System Impact Assessment Addendum

Project: Leaside to Bridgman Reinforcement
CAA ID 2006-238

Applicant: Hydro One Networks Inc.

Date: January 25th, 2010

Figure 1: Proposed Connection

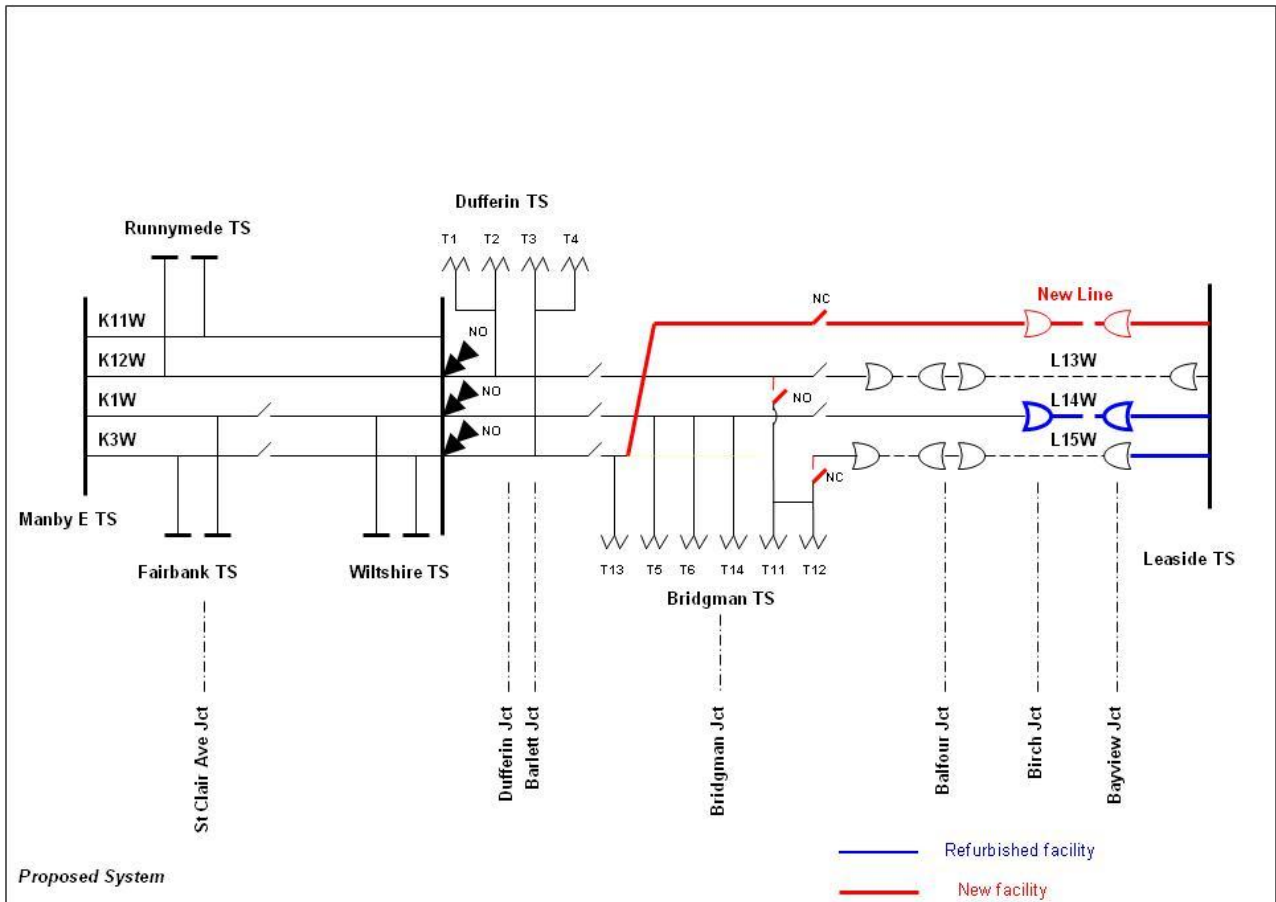
(a) L14W/L15W will be rebuilt as a three circuit 115 kV line between Leaside TS and Bayview Jct. (about 1.7km). All three circuits will have an ampacity rating of 1200A at 35°C ambient temperature.

(b) Two underground 115kV cable circuits will be built between Bayview Jct. and Birch Jct. (about 2.2km). Both U/G cable circuits will have an ampacity rating of 1200A. One cable will replace the old L14W cable in that section. The other cable will be for the new circuit.

(c) Birch Jct. x Bridgman TS overhead section of line L14W carries an idle 115kV circuit. The idle section on this line will be used for the new circuit. It will have an ampacity rating of 1200A at 35°C ambient temperature.

(d) The new circuit will be incorporated at Leaside on the same diameter with L4C and H8LC, by adding a new 3000 A breaker – see Figure 3.

(e) A new motorized disconnect switch will be installed on the new circuit at Bridgman Junction, on Leaside side.

(f) The L15W circuit will be open at Bridgman TS. The new circuit will be connected to the Bridgman TS to Wiltshire TS section of the L15W circuit, and will supply Bridgman T13, and Dufferin T3 and T4.

(g) Bridgman T11 and T12 will be disconnected from L13W and connected to L15W, on Leaside side. Two motorized disconnect switches at Bridgman Junction, a normally open disconnect switch between L13W and Bridgman T11+T12, and a normally closed disconnect switch between L15W and Bridgman T11+T12, will allow this transfer.

Figure 2: Proposed Connection at Leaside

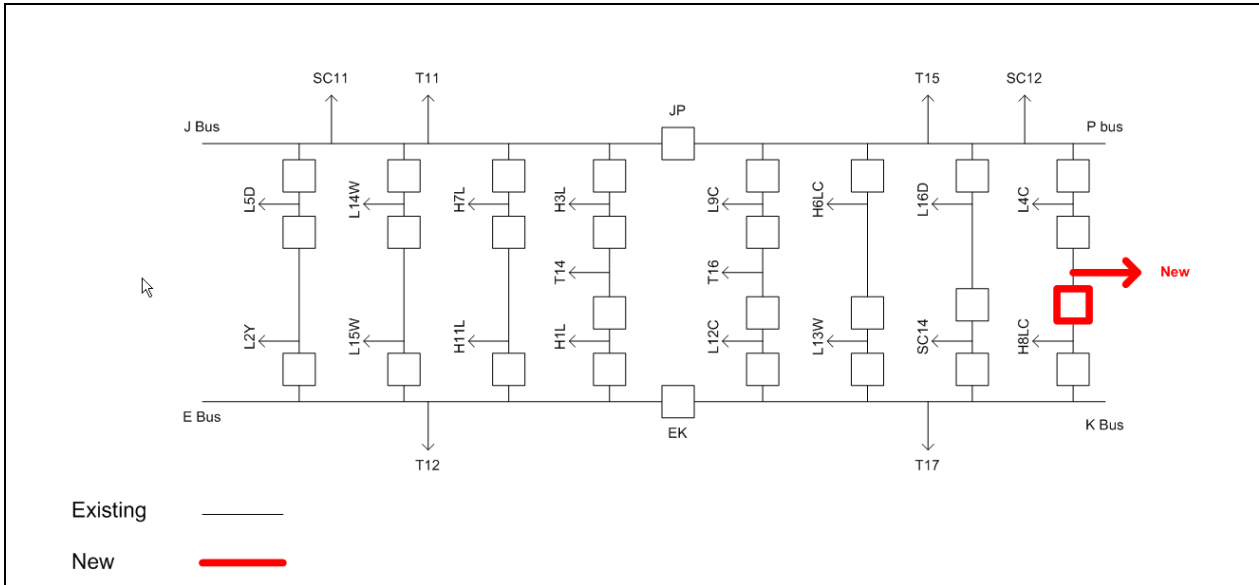
1. The original SIA recommended the new circuit to have its own terminal at Leaside TS for operation flexibility and to prevent operating challenges during switching, and potential feed-back during certain element outages and system configurations. Hydro One decided to create a terminal for the new circuit by installing one additional 115 kV breaker at Leaside TS on the same diameter with the

circuits L4C and H8LC, resulting in the three circuits connecting to a one-and-a-third breaker diameter configuration, as shown in Figure 2.

The original SIA recommended the new circuit to have its own terminal at Leaside TS for operation flexibility and to prevent operating challenges during switching, and potential feed-back during certain element outages and system configurations. Hydro One decided to create a terminal for the new circuit by installing one additional 115 kV breaker at Leaside TS on the same diameter with the circuits L4C and H8LC, resulting in three circuits connecting to a one-and-a-third breaker diameter configuration, as shown in Figure 2.
